23 September 2022

GS#610-012 MCM LeFleur's Bluff Park Improvements (Phase 2)
Mississippi Department of Wildlife, Fisheries, and Parks

ADDENDUM NO. 02

C401
GRADING & DRAINAGE
PLAN - ADD ALTERNATE 1
- WALKING TRAIL

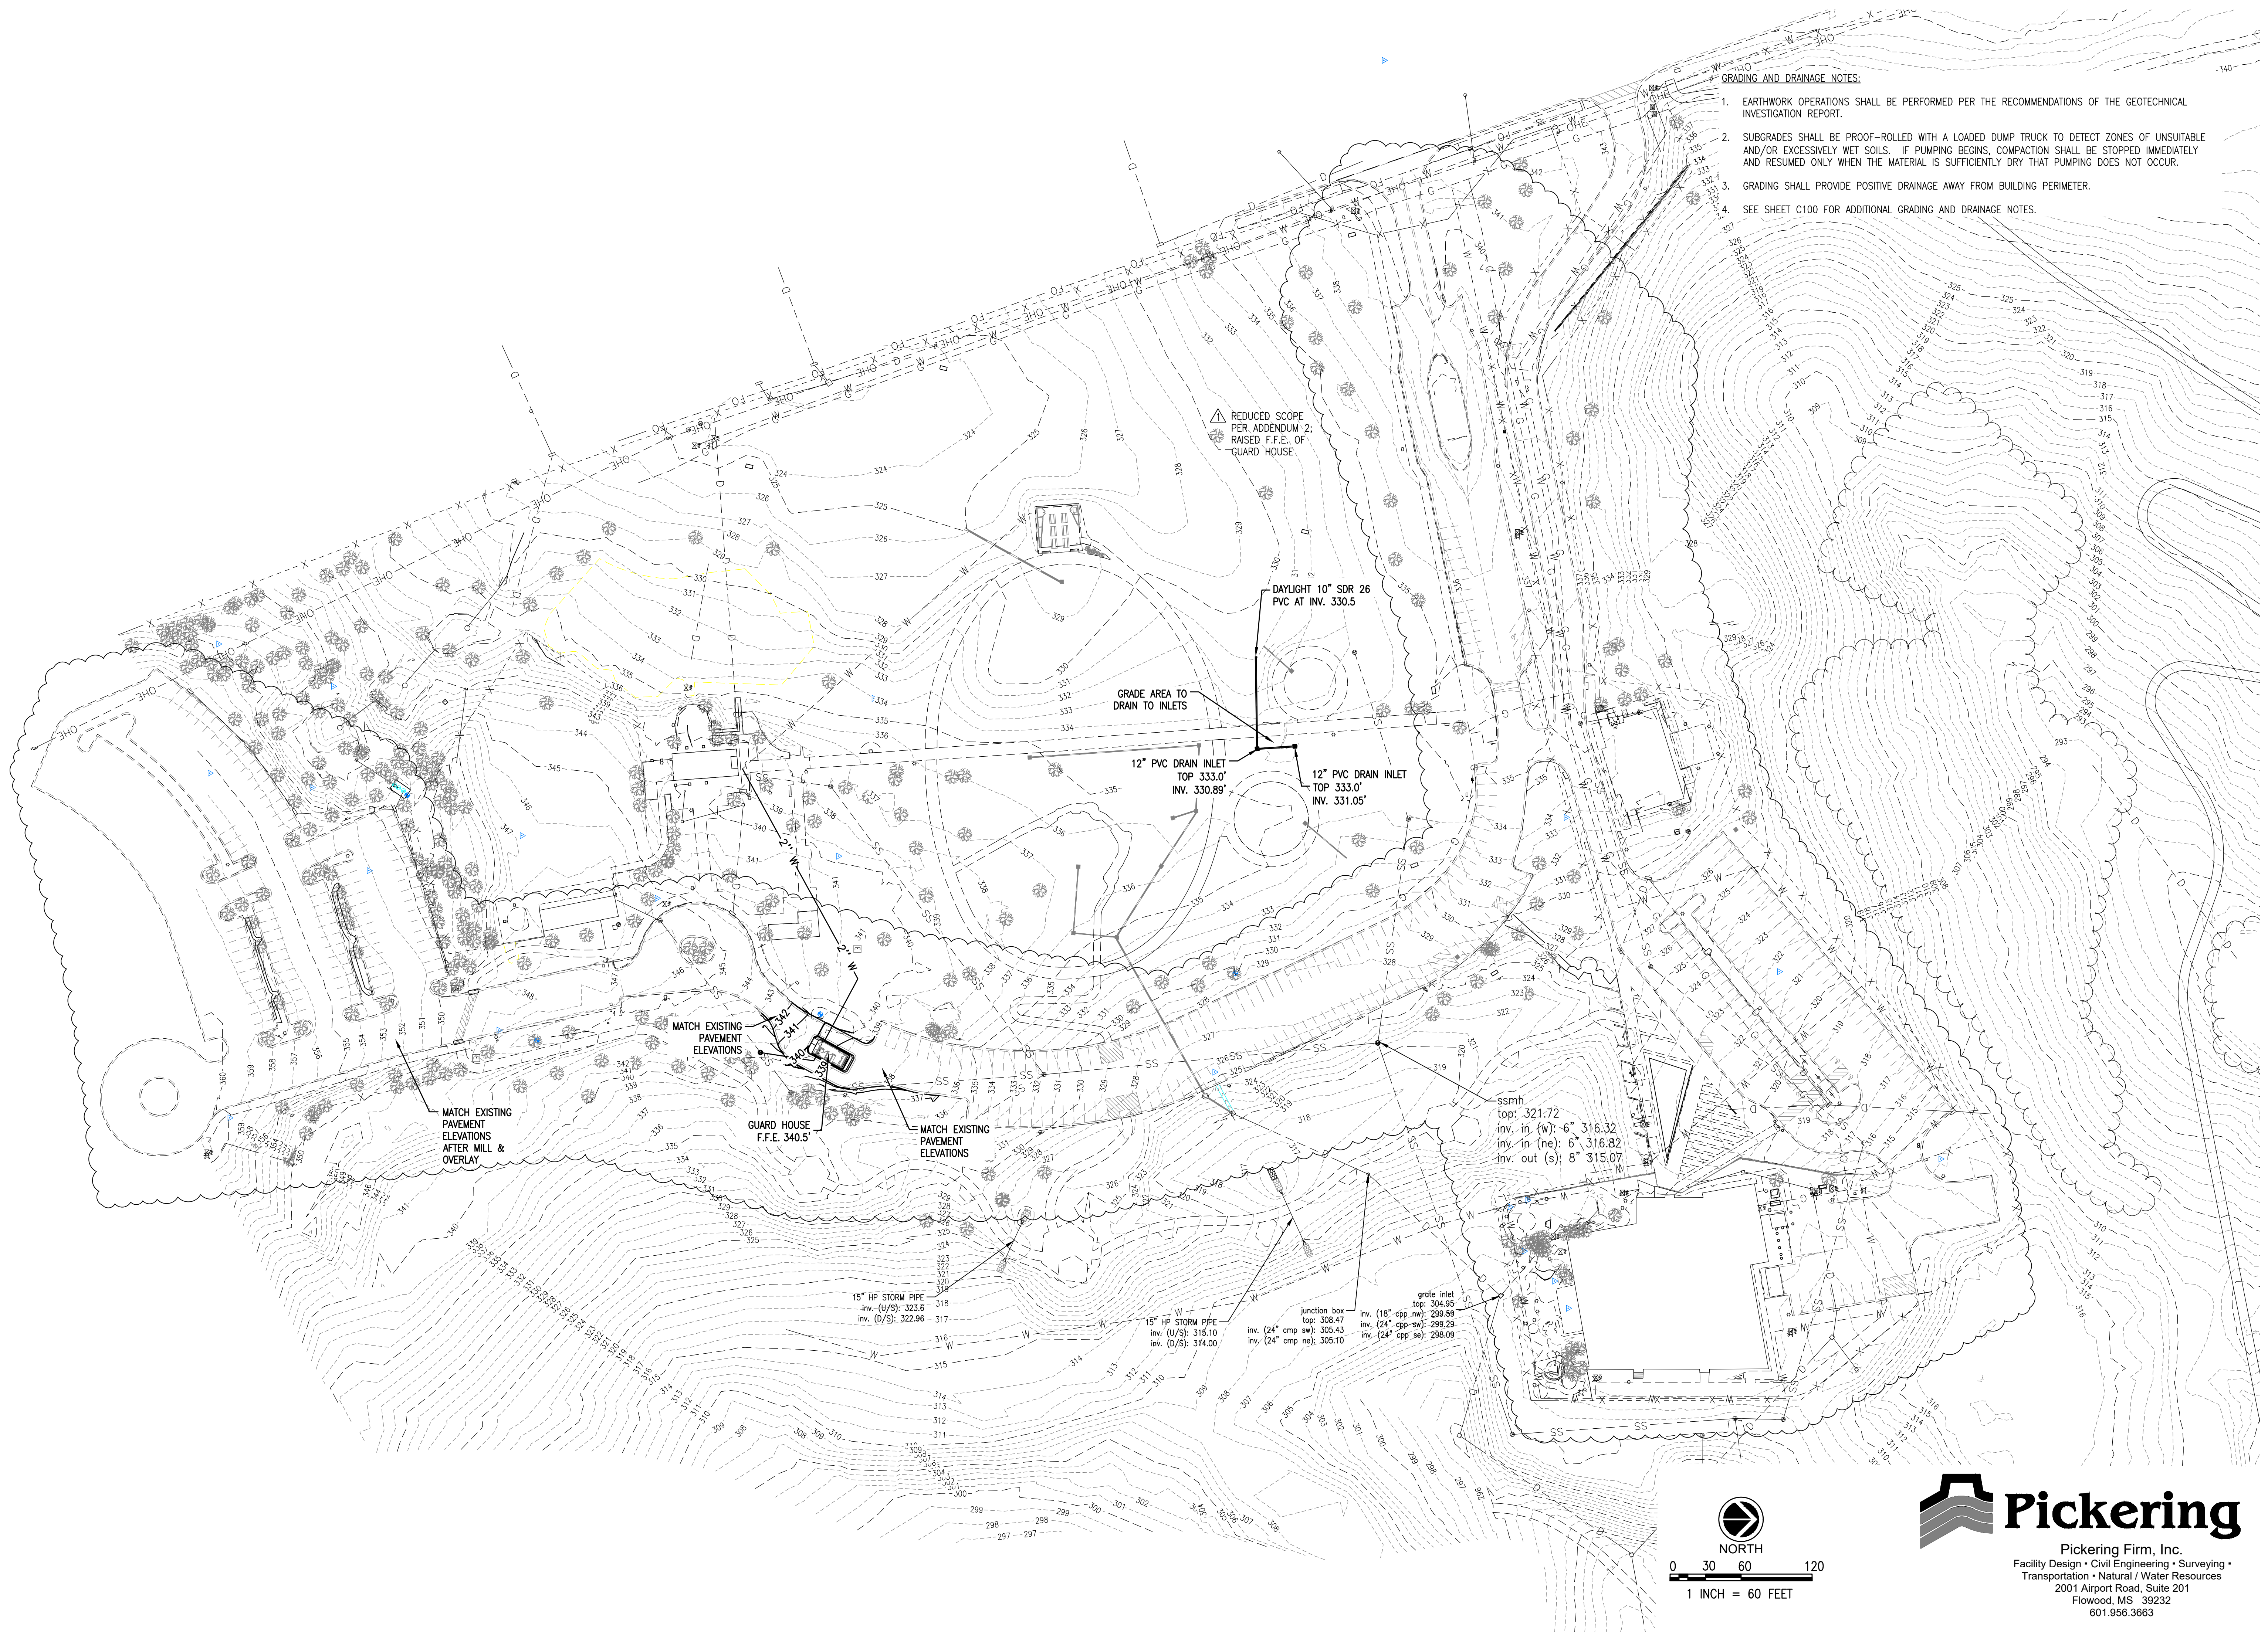
- ITEM NO. 10** **C400 – GRADING & DRAINAGE PLAN**
REPLACE sheet with the attached C400.
REVISES Base Bid by removing scope of work.
- ITEM NO. 11** **C401 – GRADING & DRAINAGE PLAN – ADD ALTERNATE 1 – WALKING TRAIL**
REPLACE sheet with the attached C401.
REVISES Alternate 01 by removing existing concrete adjacent to trail.

C500
EROSION CONTROL
PLAN

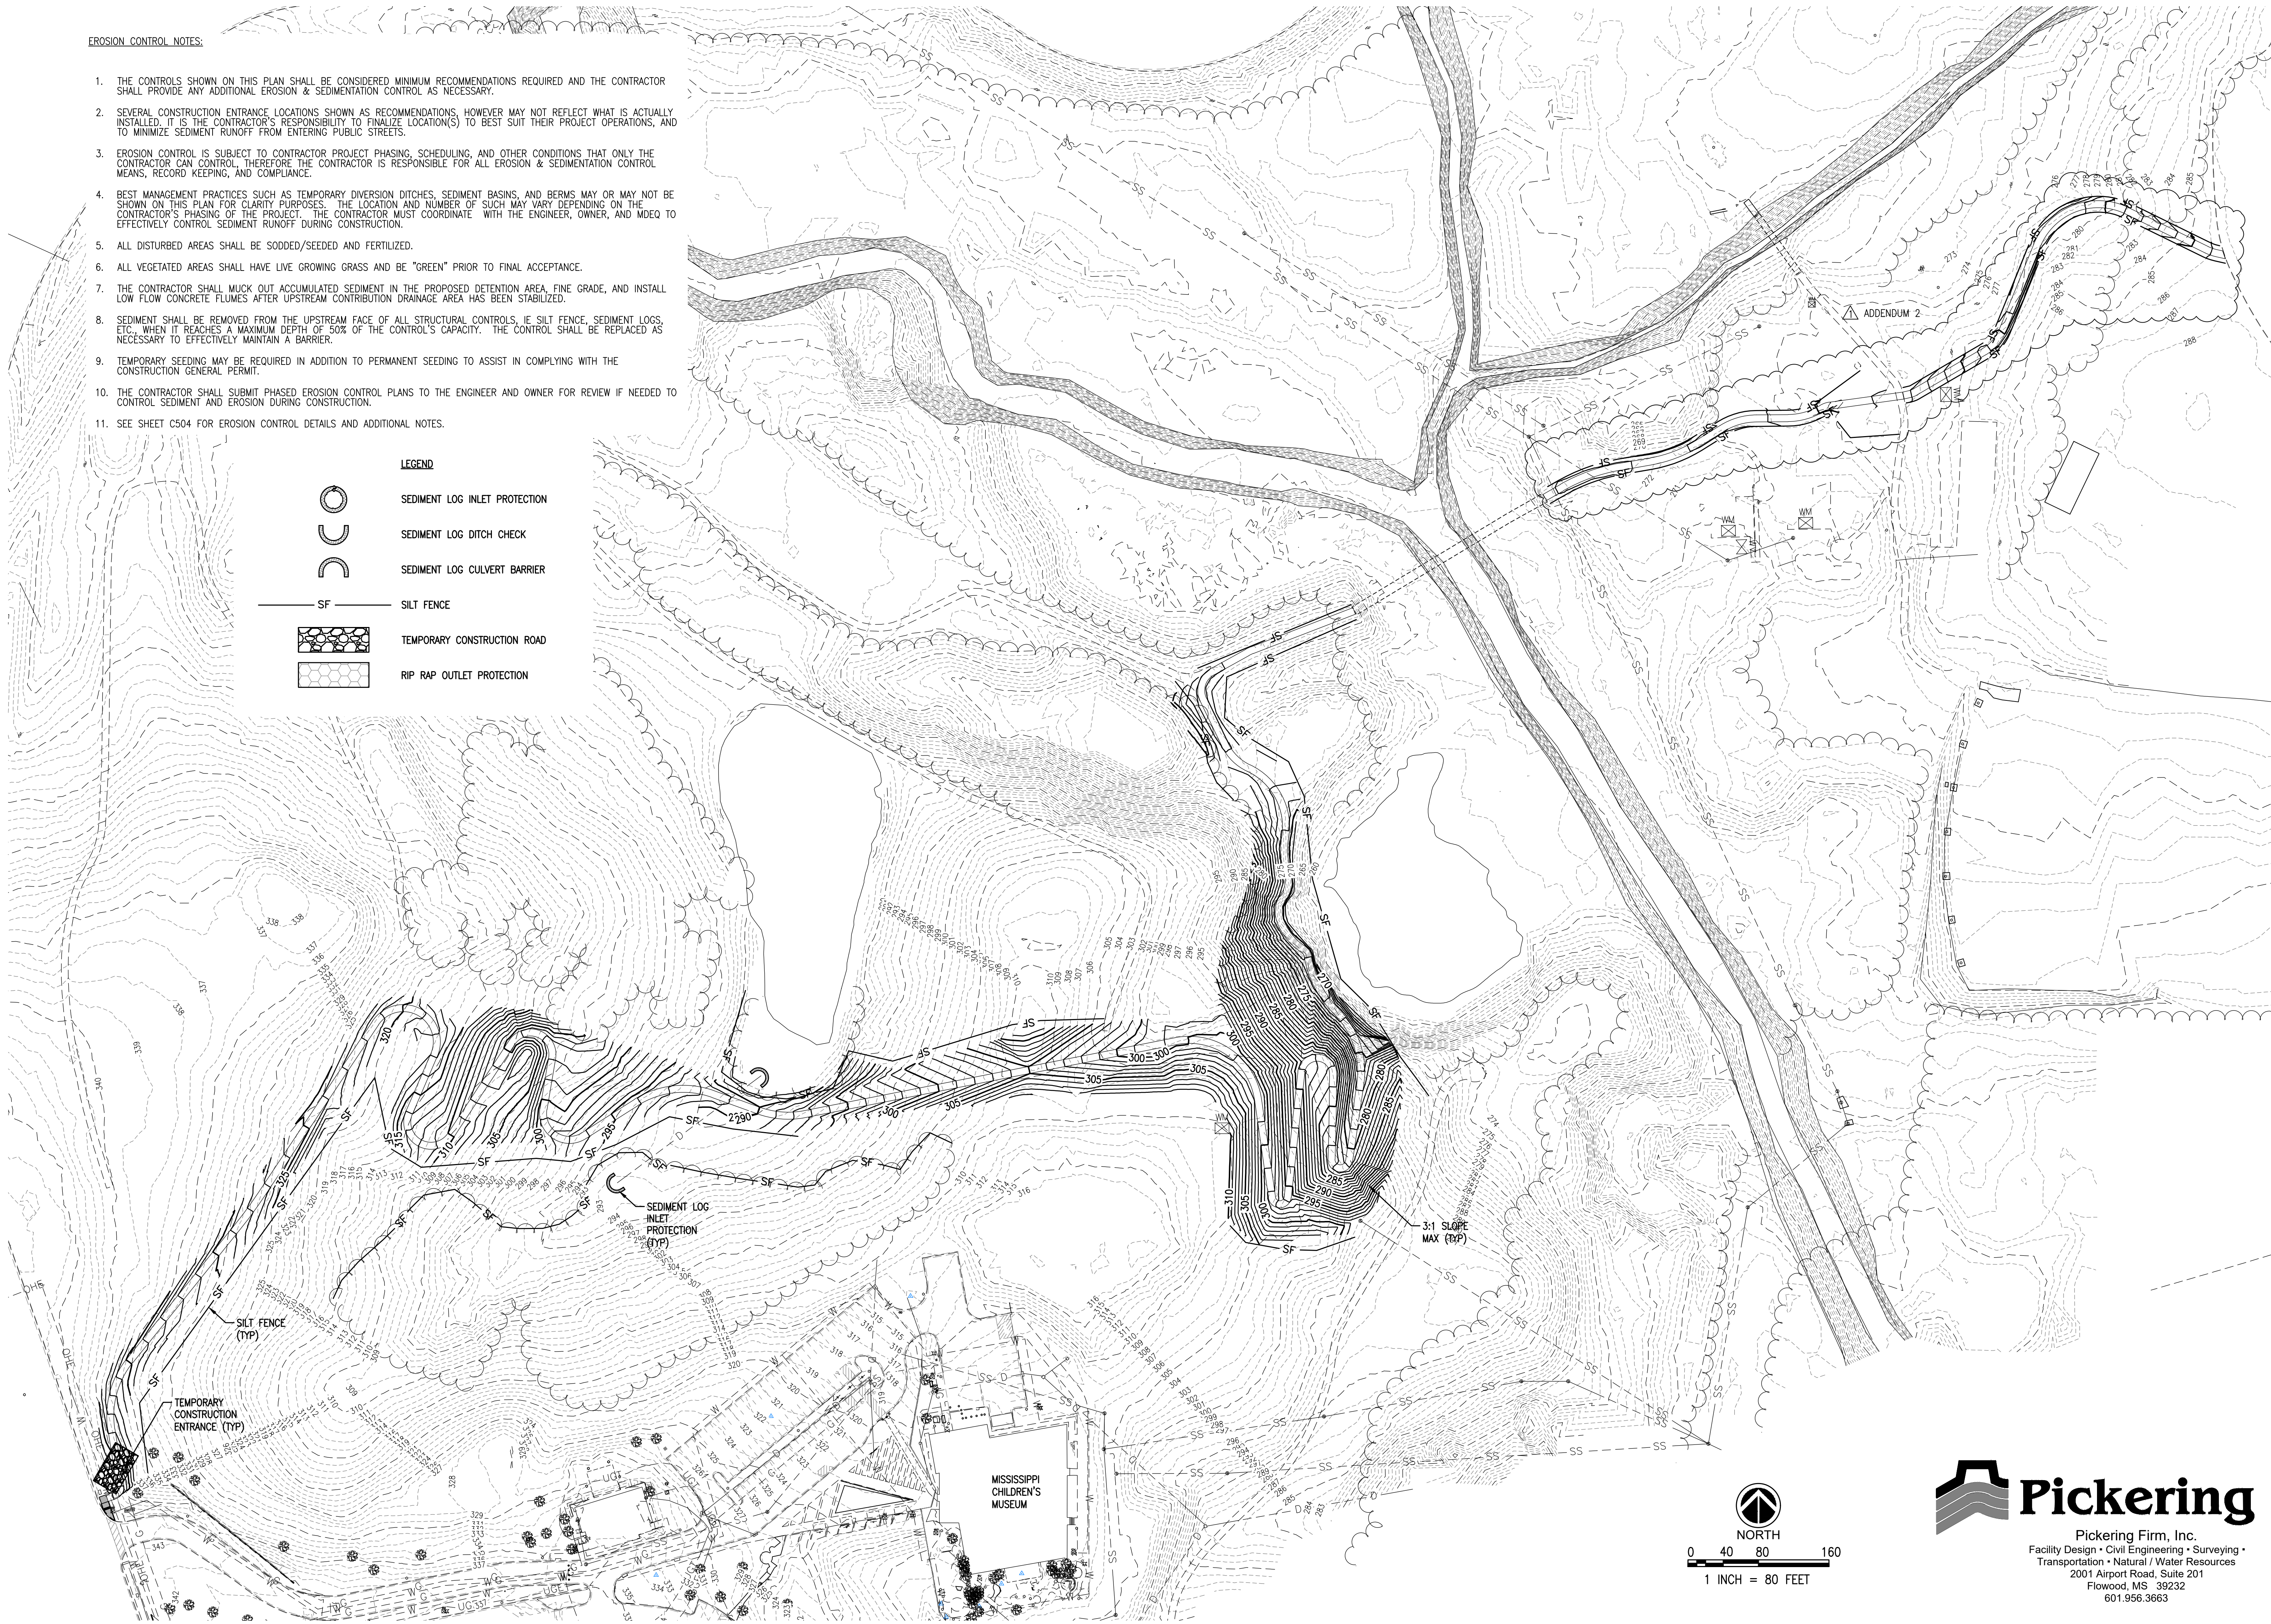
- ITEM NO. 13** **C500 – EROSION CONTROL PLAN**
REPLACE sheet with the attached C500.
REVISES Base Bid by removing scope of work.
- ITEM NO. 14** **C501 – EROSION CONTROL PLAN – ADD ALTERNATE 1 – WALKING TRAIL**
REPLACE sheet with the attached C501.
REVISES Alternate 01 by removing existing concrete adjacent to trail.

E1.0
SITE PLAN -
PHASE 2

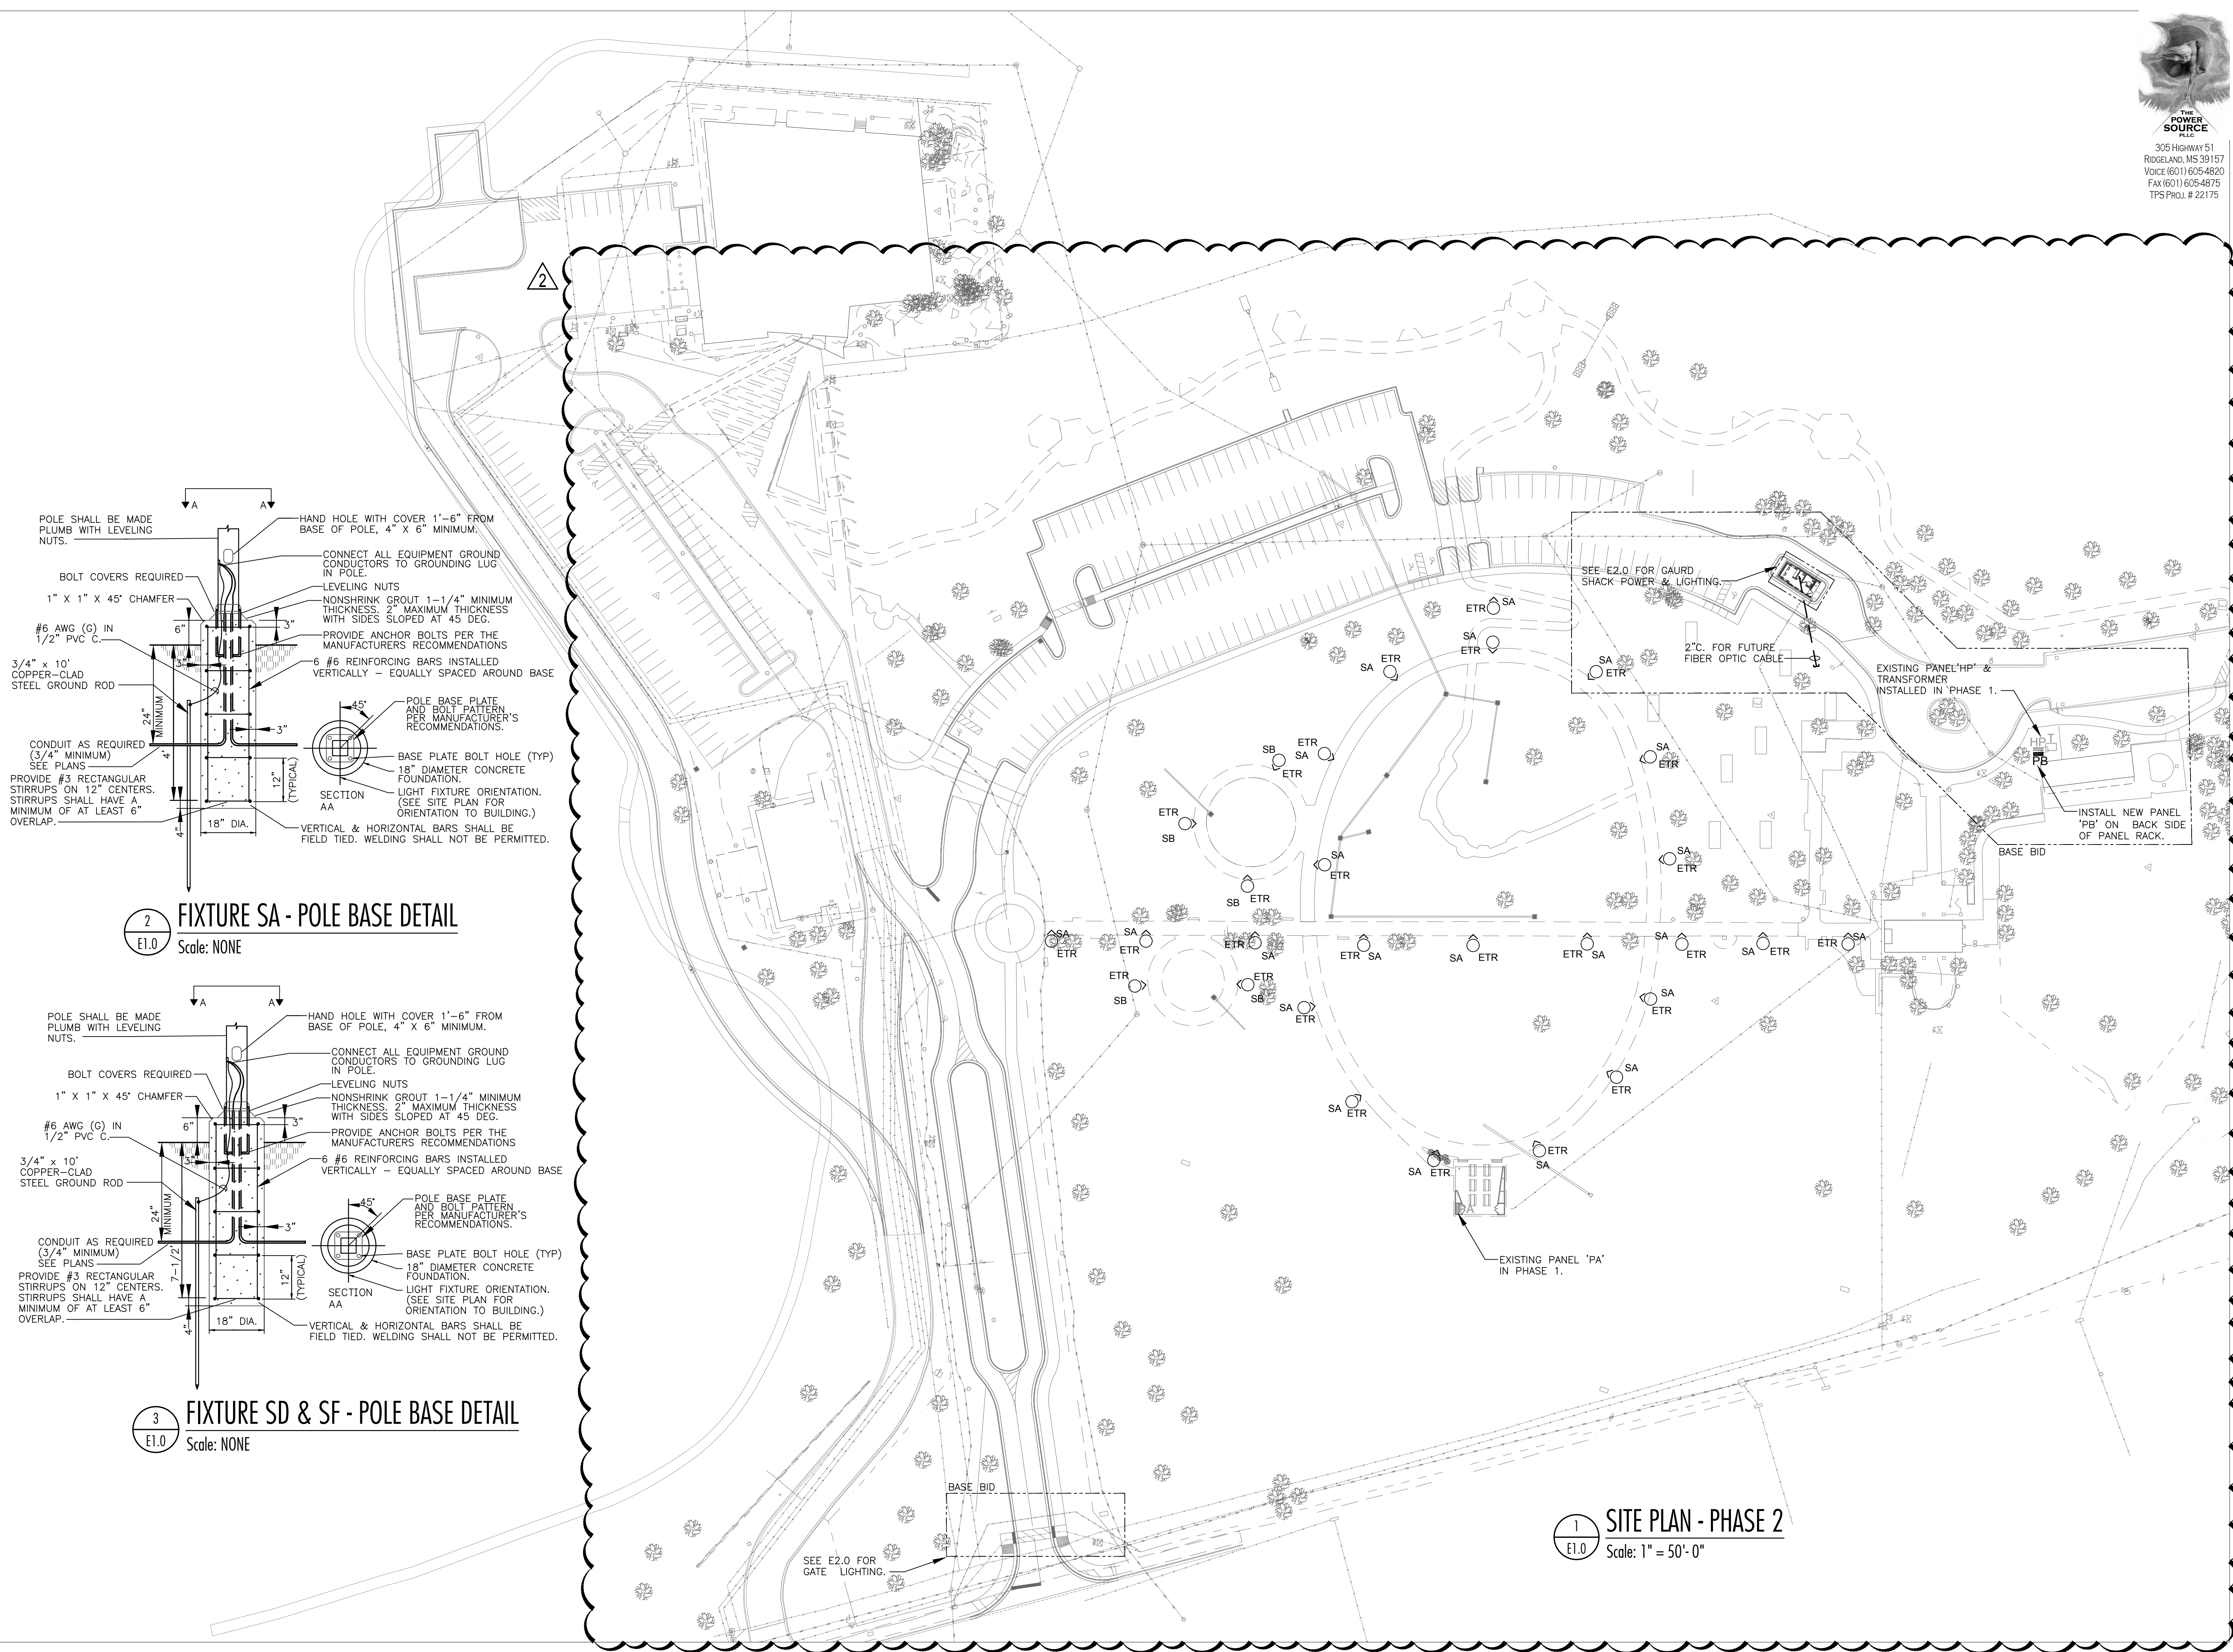
- ITEM NO. 21** **E0.0 – LEGEND SHEET**
REPLACE sheet with the attached **E0.0.**
REVISES Lighting Fixture and Panel schedule.
- ITEM NO. 22** **E1.0 – SITE PLAN-PHASE 2**
REPLACE sheet with the attached **E1.0.**
REMOVES site lighting scope from project.
- ITEM NO. 23** **E2.0 – LIGHTING AND POWER PLAN**
REPLACE sheet with the attached **E2.0.**
ADDS wall pack fixtures to Ranger/Information Station.
REVISES lighting plan at Entry Gate.
- ITEM NO. 24** **ED1.0 – SITE PLAN-PHASE 2**
REPLACE sheet with the attached **ED1.0.**
ADDS scope note to demolish all electrical associated with Ranger/Information Station.
